**Staff Report**  
**Cascade River Ranch**  
**ANNEX-19-01**

Staff: Carrie Rushby  
Public Hearing: May 28, 2019  
Applicant: Steve Arnold, A-Team Land Development & Real Estate  
Owner: Cascade River LLC  
Location: North-east of Highway 55, adjacent to the Payette River  
Size of Site: 121.17 acres  
Existing Zone: Mixed Use (MU)  
Proposed Use: Mixed Use Subdivision

Subject: Cascade River Ranch Preliminary Plat

**FIGURE D103.1  
DEAD-END FIRE APPARATUS ACCESS ROAD TURNAROUND**

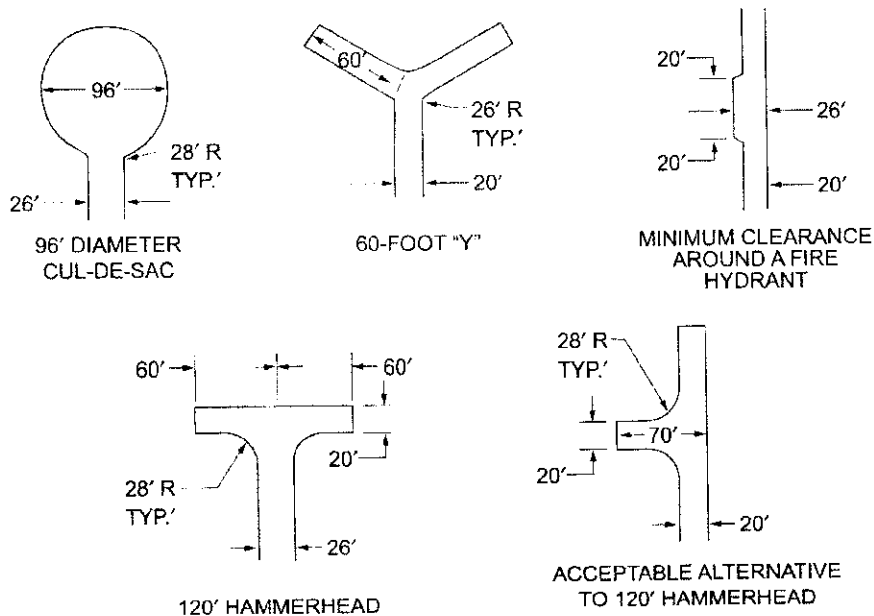
- b) All dead-end road and cul-de-sac shall meet the requirements in IFC Appendix D Figure D103.1 (attached).
- c) Fire flow for buildings shall meet the requirements in IFC (Appendix B) attached.
- d) Fire hydrant location shall meet the requirements in IFC Appendix C (attached).

- All roads shall be built to City of Cascade standards or Section 503.2 IFC 2015.
- All dead-end road and cul-de-sac shall meet the requirements in IFC Appendix D Figure D103.1 (attached).

**D103.1 Access road width with a hydrant.** Where a fire hydrant is located on a fire apparatus access road, the minimum road width shall be 26 feet (7925 mm), exclusive of shoulders (see Figure D103.1).

LENGTH (feet)	WIDTH (feet)	TURNAROUNDS REQUIRED
0-150	20	None required
151-500	20	120-foot Hammerhead, 60-foot "Y" or 96-foot diameter cul-de-sac in accordance with Figure D103.1
501-750	26	120-foot Hammerhead, 60-foot "Y" or 96-foot diameter cul-de-sac in accordance with Figure D103.1
Over 750		Special approval required
